THE MEADOWS SUBDIVISION

P.O.A.D.P.

REQUEST FOR REVIEW of POADP

POADP NAME: THE MEADOWS

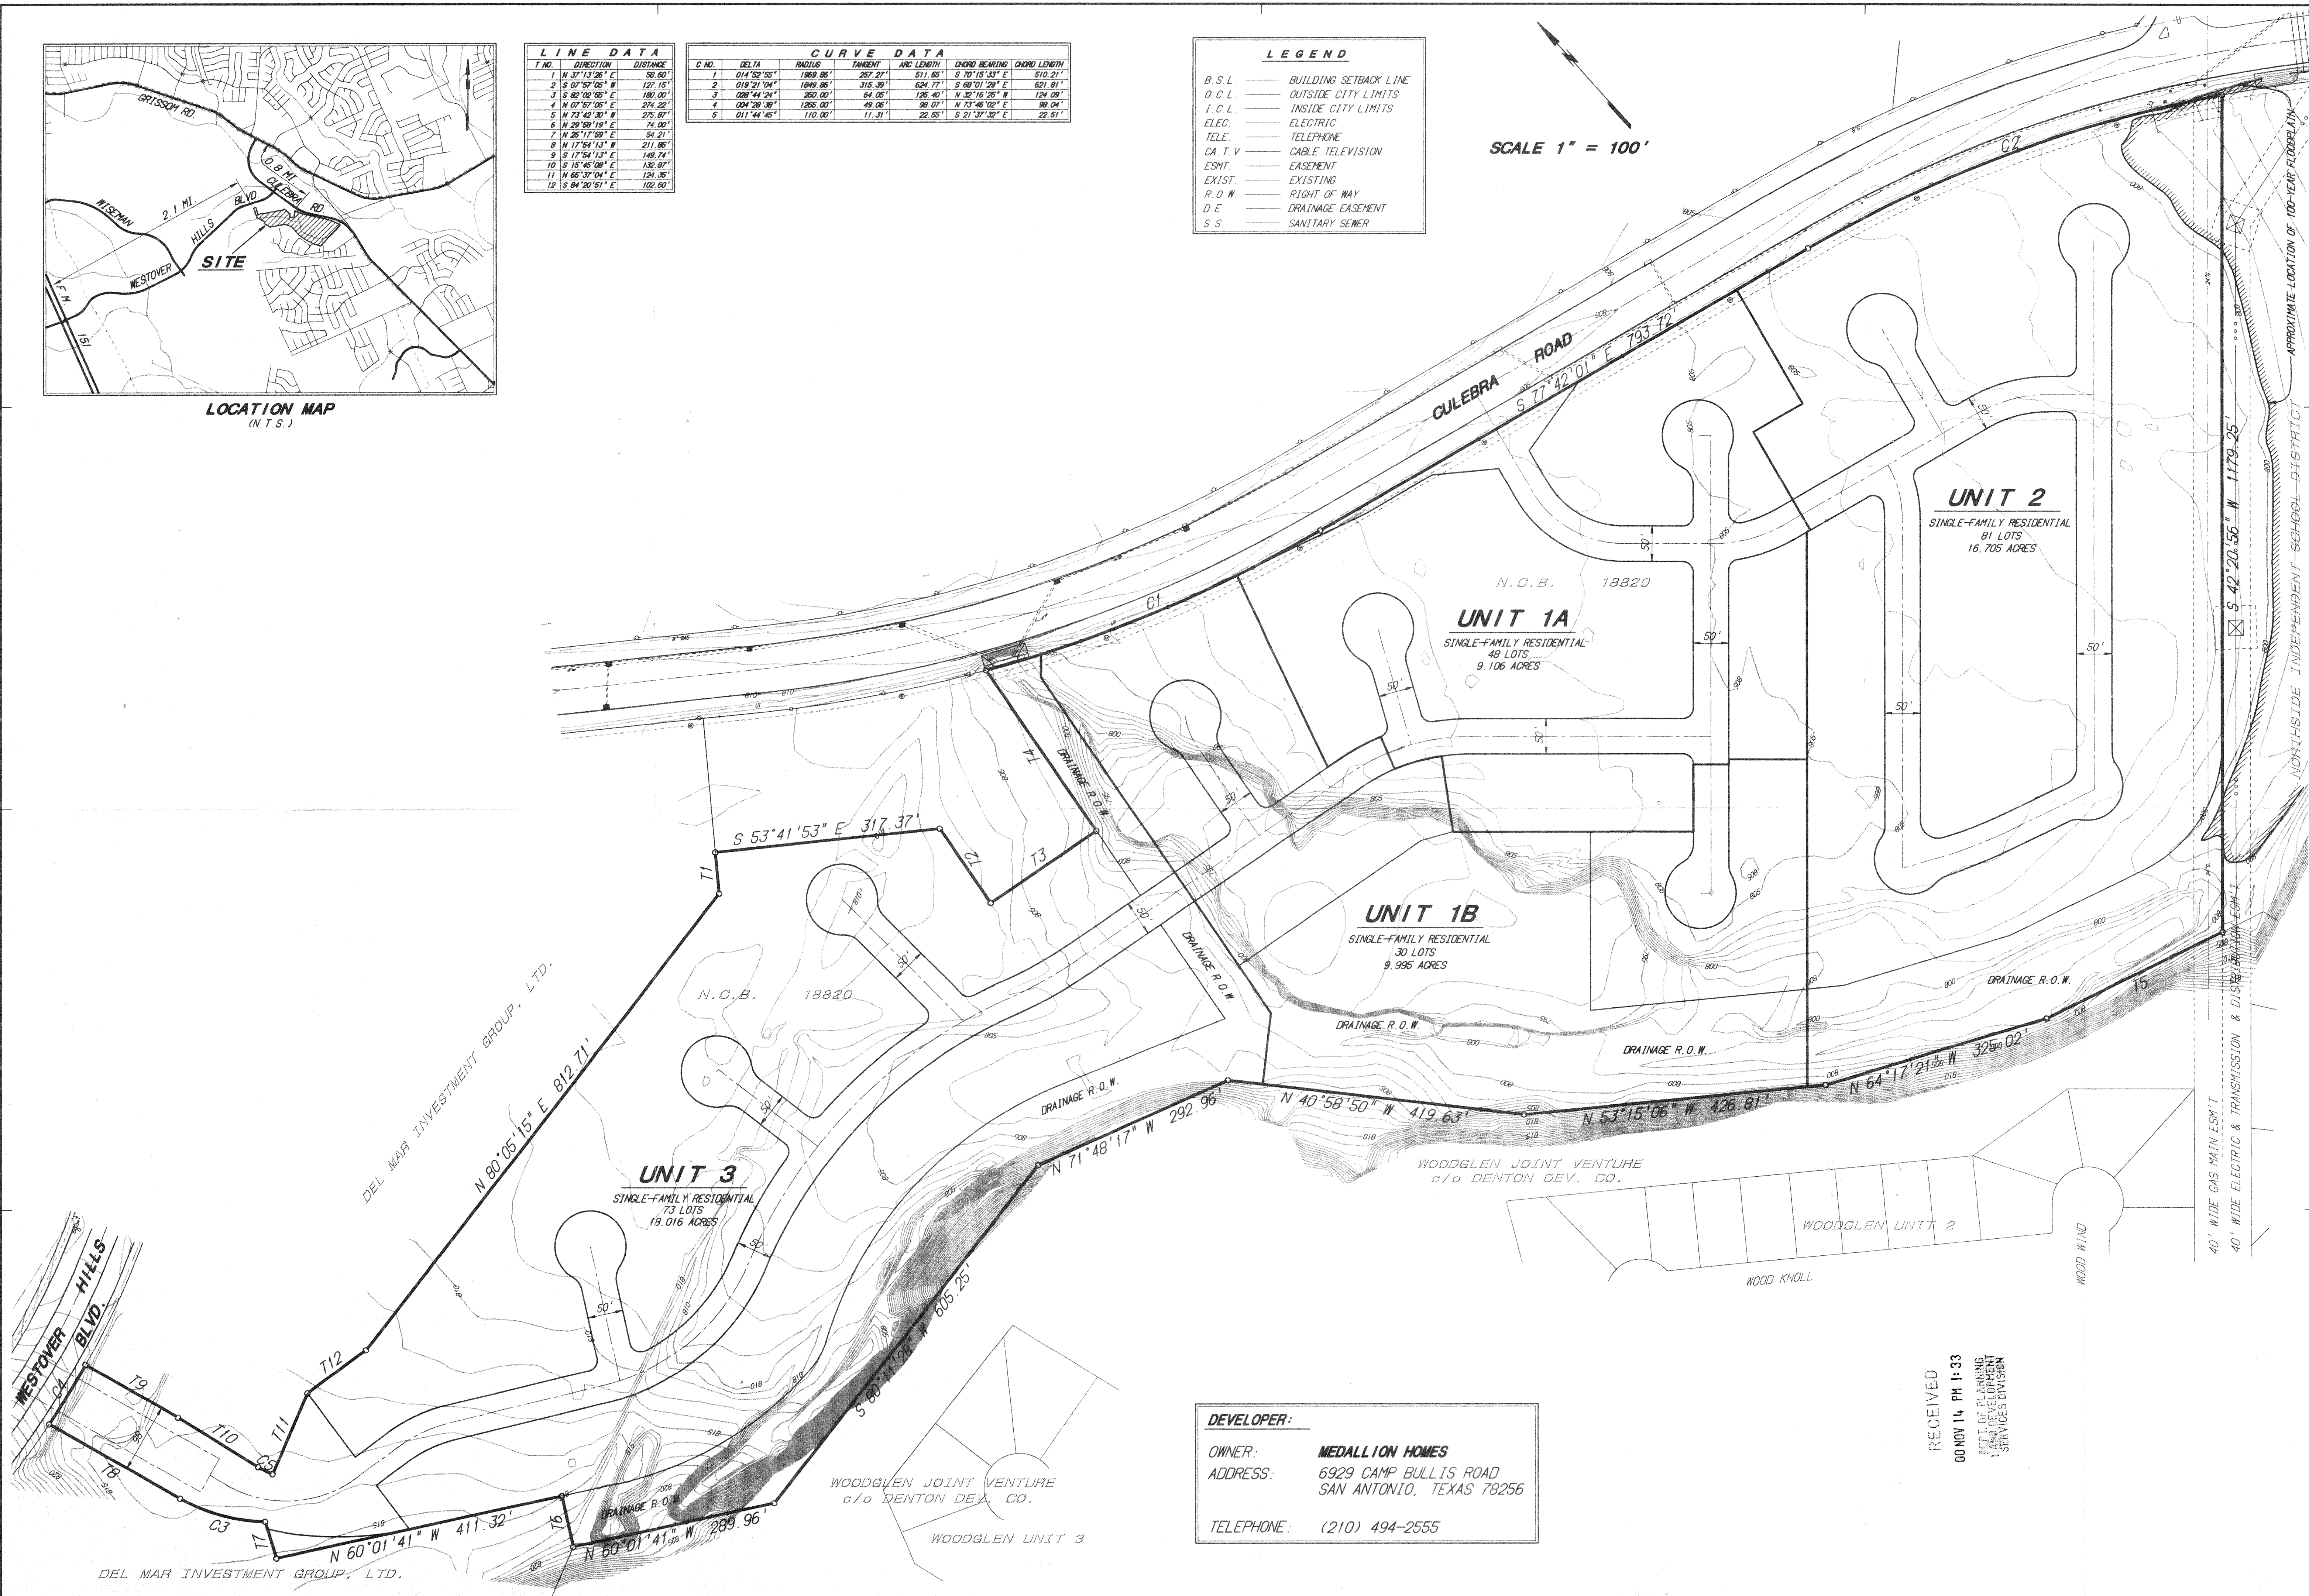
Comments: CULEBRA ROAD IS ON THE MTP AND TXDOT SYSTEM REQUIRING
A MIN OF 110' ROW AND TXDOT RELEASE. WESTOVER HILLS IS ON
THE MTP REQUIRING A MIN. OF 86' ROW.

Comments: CULEBRA ROAD IS ON THE MTP AND TXDOT
SYSTEM REQUIRING A MIN. OF 110' ROW AND TXDOT
RELEASE. WESTOVER HILLS IS ON THE MTP REQUIRING
A MIN. OF 80' ROW. THIS PROPOSE POADP NEED TO
SHOW ROW AND ROADWAY DEDICATION IF REQUIRED. ALSO
REQUIRES TXDOT RELEASE.

Comments: Show low on culvert & west over H&A.
Show existing Medians.
Check for sight distance @ intersections.

Comments: zoned R-1 (R-5)

<u>P.O.A.D.P. Reviewed for:</u>	<u>Comments</u>
Noise Mitigation	For residential development directly adjacent to State ROW, the developer shall be responsible for adequate set-back and/or sound abatement.
R.O.W. Requirements	FM 3487 requires a minimum right of way width of 120'.
Access Limits/Restrictions	Locations of access points will be as directed by Regulations For Access Driveways to State Highways. This property is eligible for a single access point to FM 3487.
WPAP Requirements	None.

Corrected Zoning from P1-R7 to P1-R5 per our conversation. Thanks Mike.
